Permit Number 2026-P-1790-SF
Job Address: 14305 E US Hwy 290, Manor , TX. 78653

The first submittal of the Cottonwood Subdivision Short Form Final Plat (*Short Form Final Plat*) submitted by LRG Engineering LLC and received on February 10, 2026, have been reviewed for compliance with the City of Manor Subdivision Ordinance 263B.

Response to Comments
Permit Number 2026-P-1790-SF
Job Address: 14305 E US Hwy 290, Manor , TX. 78653

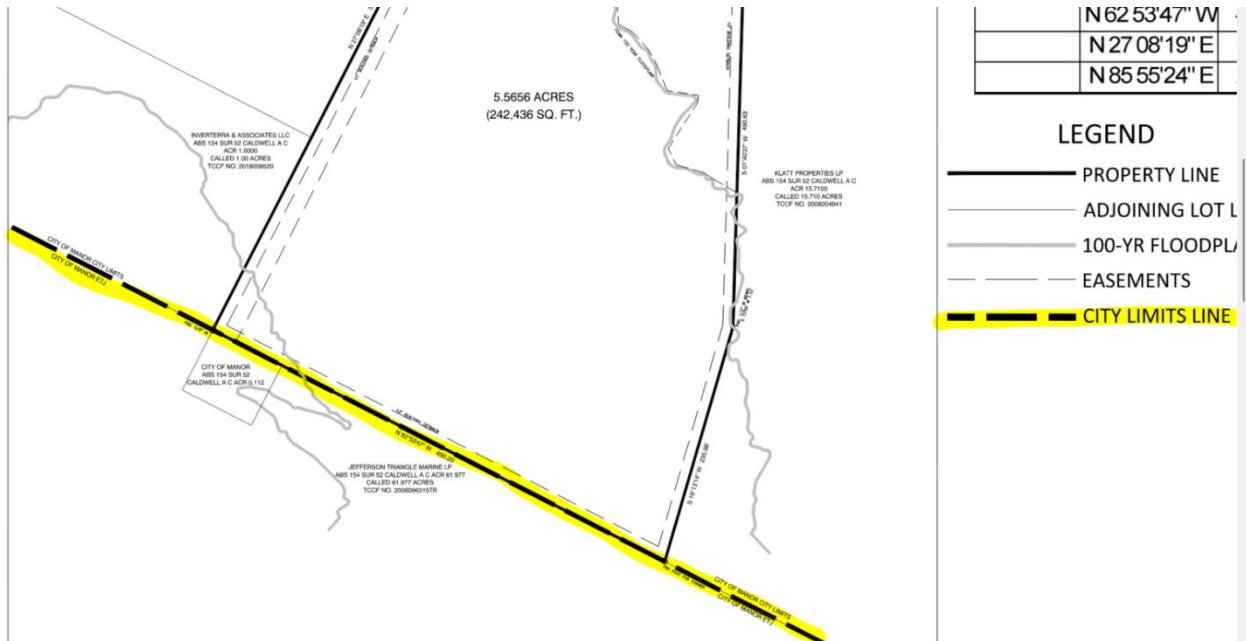
- vii. Lot area, width and depth, public utility and drainage easements, and setbacks shall conform to the requirements as established for the designated land use.

Per C-2 zoning, the minimum requirements are as follows:

Minimum lot area: ½ acre

Minimum lot width: 100'

Front setback: 20'

Exterior side setback to non-residential: 10'

All of these requirements are met on the provided plat.
